**Memorandum**

Ders Anderson  
Openlands  
25 E Washington St # 1650  
Chicago, IL 60602Re: Burnham Greenway Gap Trail  
Railroad Comments, Engineering Draft Disposition, and Open Items

The following is a disposition to the pre-final plan review comments received from Alfred Benesch & Company (CSX Transportation, Inc.) received 1/20/2016 via email from Mr. Larry Shaw.

The following is a disposition to the pre-final plan review comments received from Signal Systems, John T. Starkey, PE (on behalf of NICTD Railroad) dated 3/31/2016.

Figure 3 – Proposed Plan's Pedestrian Barrier Details (sheet 19 of 88)

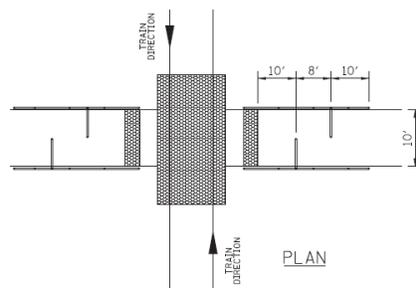
A second, but subtler, purpose of the barrier is to force users to face oncoming trains or dismount bicycles as they zigzag through the barrier. The current design of the pedestrian barrier may not be as effective in

achieving these results because of the narrow width of the pathway and the length of and distance between the projecting barriers. A barrier system that has longer projecting barriers with a shorter distance between the projecting barriers would force a user to physically turn and face oncoming trains and be harder to ride a bicycle through without dismounting.

Figure 4 – Proposed Plan’s Pedestrian Barrier Location at NICTD (sheet 21 of 88)

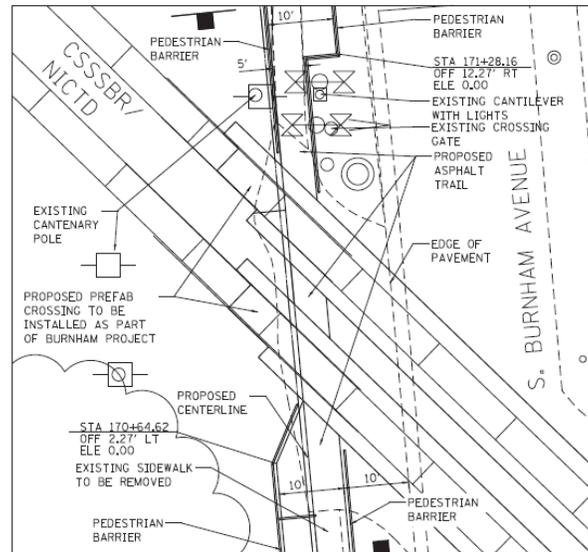
- *Response: The final design will be determined pending the ICC decisions at these combined crossings.*
3. Comment: The location of the barrier and associated fencing shown on page 21 of the Proposed Plan is not to drawn to scale. The distance from the barrier is not specified, however; the fencing as shown relative to the gate is not practical. The fencing, as shown, may interfere with the operation and descent of the gate arm. The fencing will also obstruct maintenance personnel from opening the gate mechanism's door and accessing inside the gate mechanism.

The location of the barrier and associated fencing shown on page 21 of the Proposed Plan is not to drawn to scale. The distance from the barrier is not specified, however; the fencing as shown relative to the gate is not practical. The fencing, as shown, may interfere with the operation and descent of the gate arm. The fencing will also obstruct maintenance personnel from opening the gate mechanism’s door and accessing inside the gate mechanism.

- *Response: Comment noted. The final plans will ensure that the projected ped barriers are dimensioned, and that the fencing will not conflict with the operation and descent of the gate arm. A plan-in-hand walk-through with NICTD personnel would be ideal for final improvements.*

**BIKE LANE RAILROAD CROSSING TREATMENTS**  
 Figure 42-3I

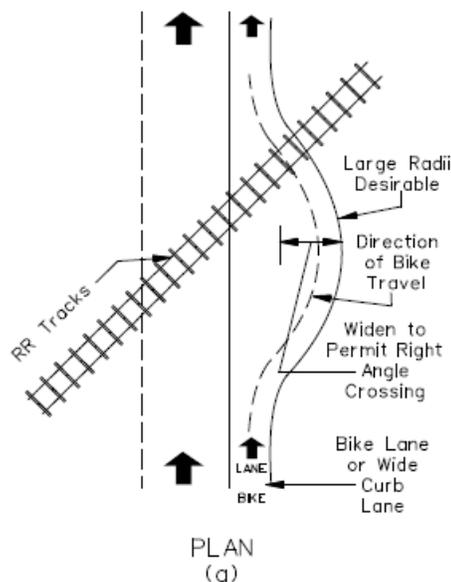
- *Response: With regards to the crossing angle, IDOT does not mandate a specific maximum allowed skew. According to the IDOT Bureau of Local Roads & Streets Manual (Chapter 42) and the Bureau of Design and Environment Manual (Chapter 17), when the crossing angle is less than 45° and it is not possible to improve the angle of approach, commercially available compressible flangeway fillers should be used to provide a smooth transition over the rails. (See below figure from IDOT BLRS Manual, Chap. 42).*

Exhibit 1  
 ALTERNATE LOCATION OF  
 BICYCLE PATH GRADE CROSSING

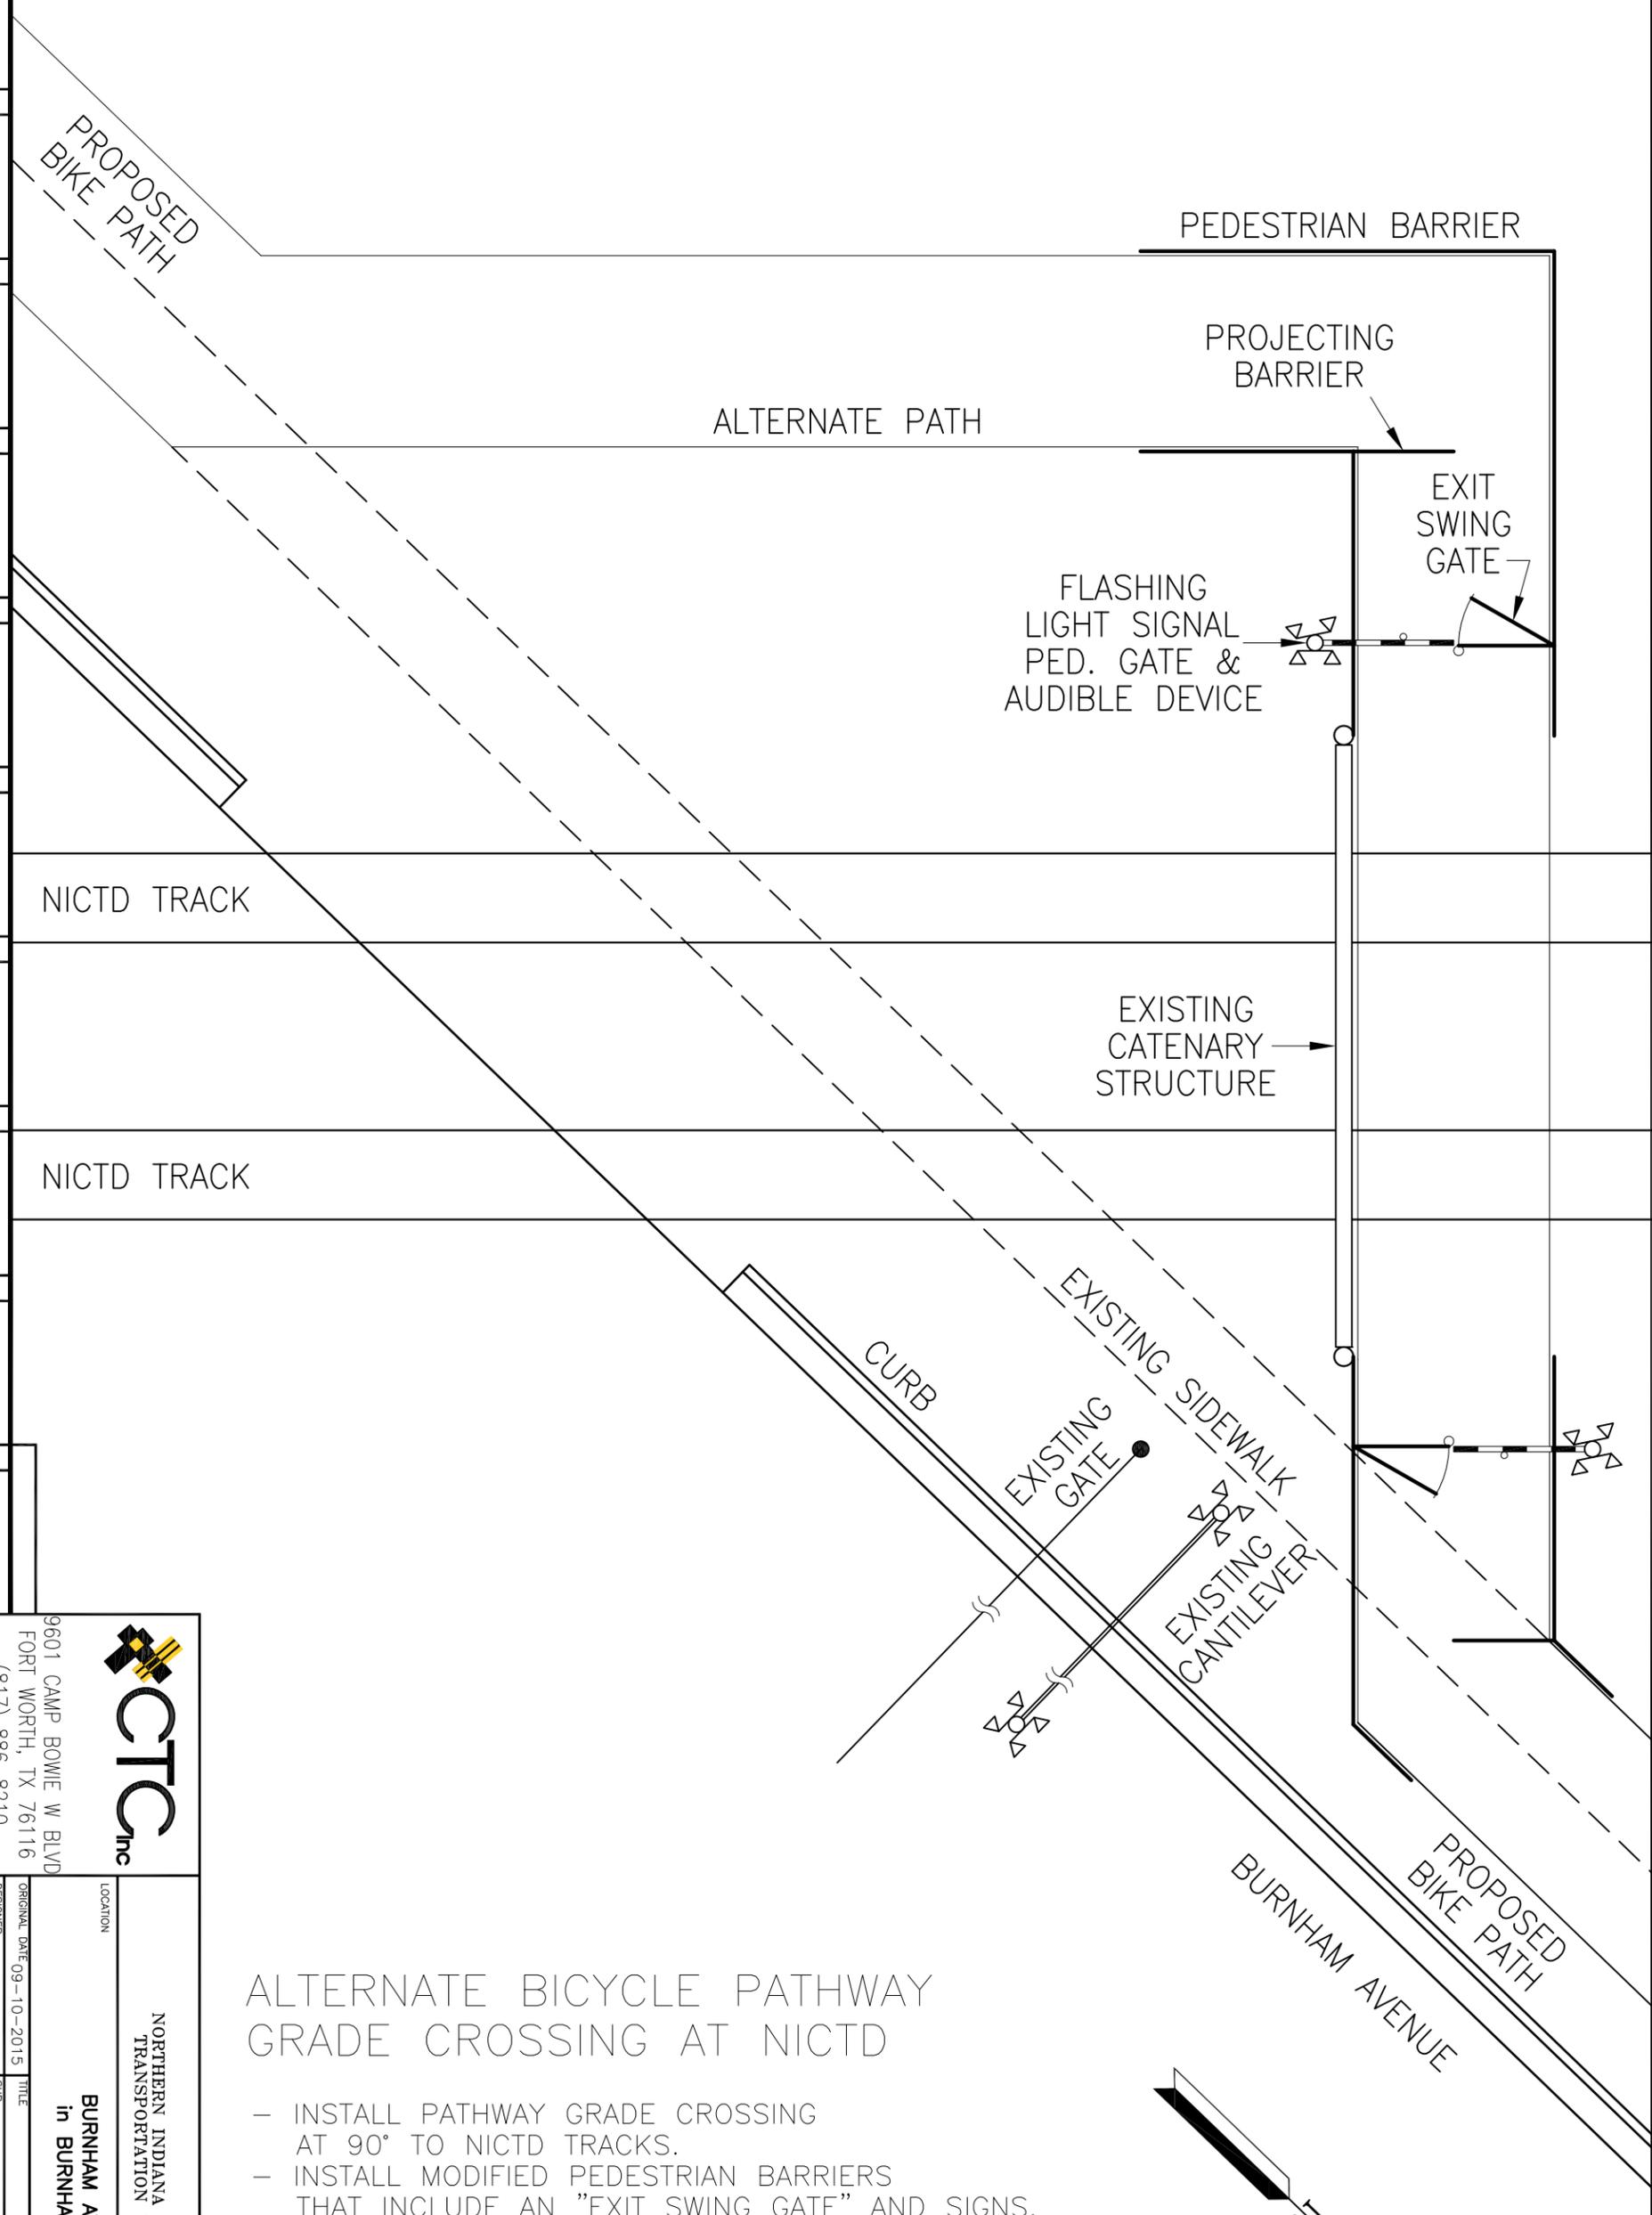
- To minimize the abovementioned concerns with the Proposed Plan and Response, I recommend an alternate grade crossing plan be considered if the ICC orders that an at grade bike path/pedestrian crossing be constructed rather than a grade separation (i.e., bridge) as advocated by NICTD and other affected railroads. The attached Alternate Plan (Exhibit #1) shows the concept and includes:

- WALK YOUR BIKE signs at the entrance to the pedestrian barriers.
  - Advance warning signs, as required.
  - Appropriate fencing
- *Response: AECOM will defer to ICC's recommendations.*

Exhibit 2  
 ALTERNATE LOCATION OF  
 PEDESTRIAN GRADE CROSSING

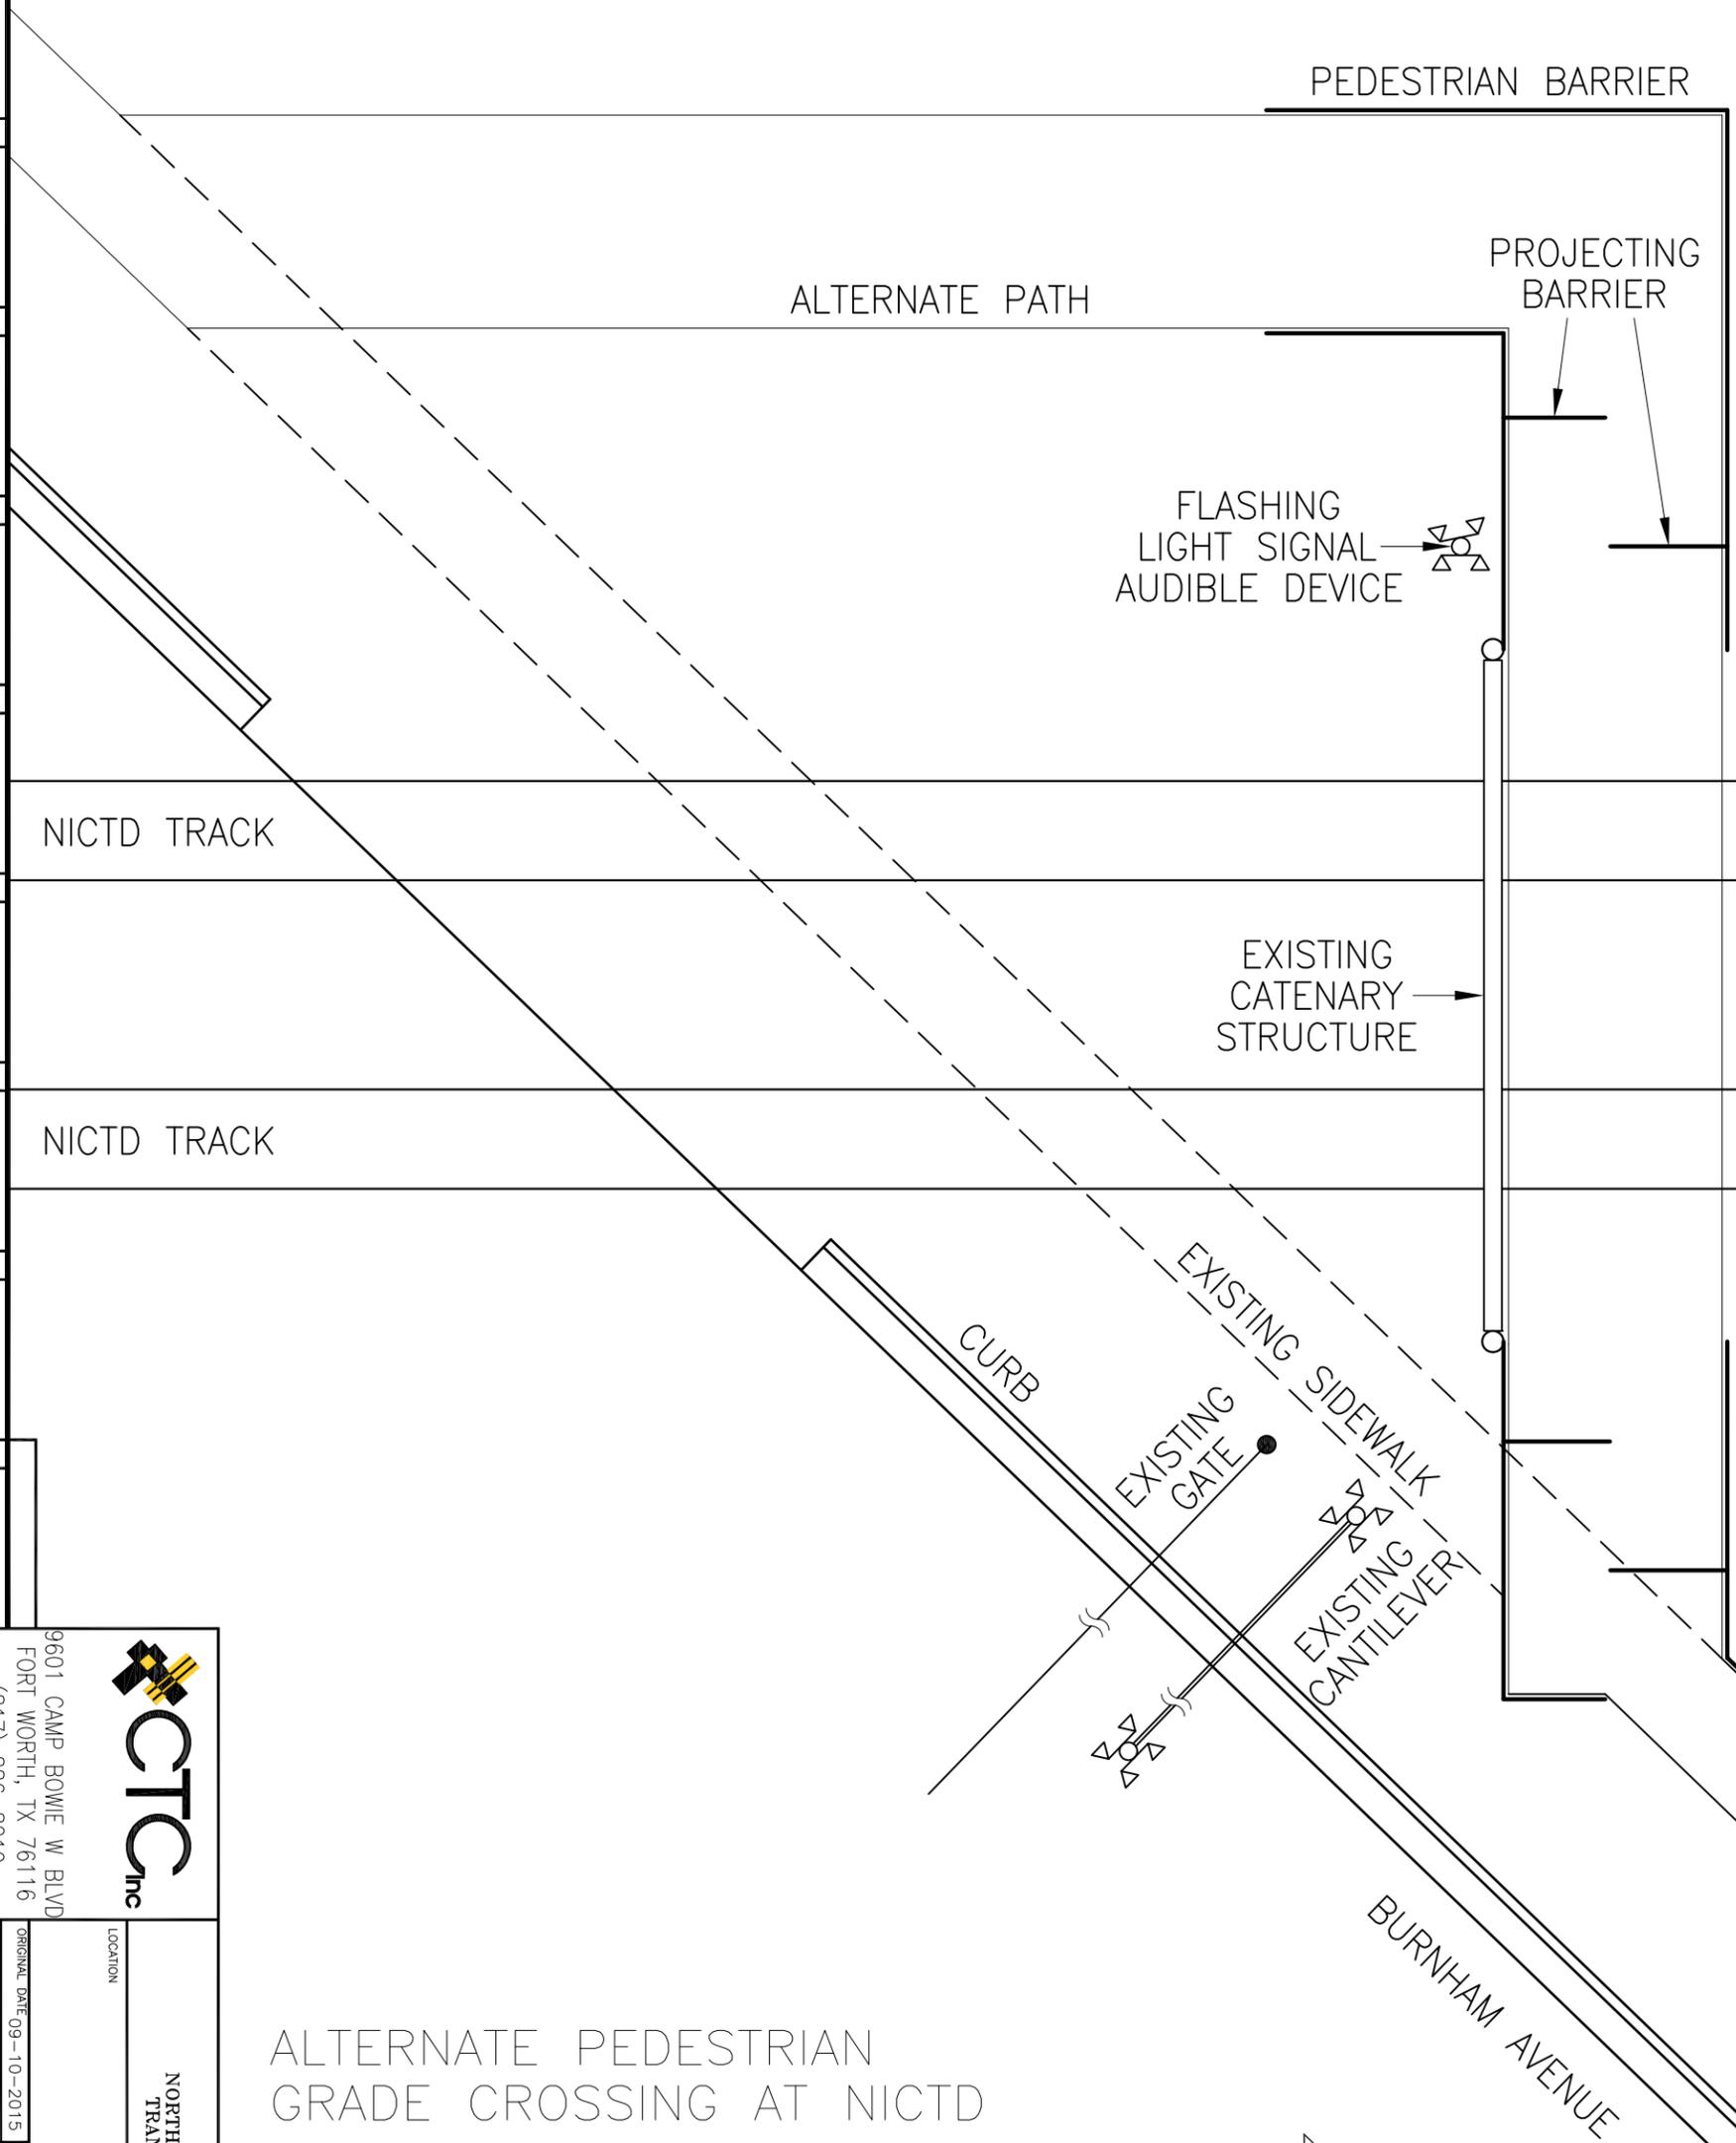
If the Commission orders that the grade separation (i.e., bridge) as advocated by NICTD and other affected Railroads be installed, certain improvements are recommended at the existing pedestrian crossing of the NICTD/CSS tracks at Burnham Avenue. The attached Alternate Plan (Exhibit #2) shows the concept and includes:
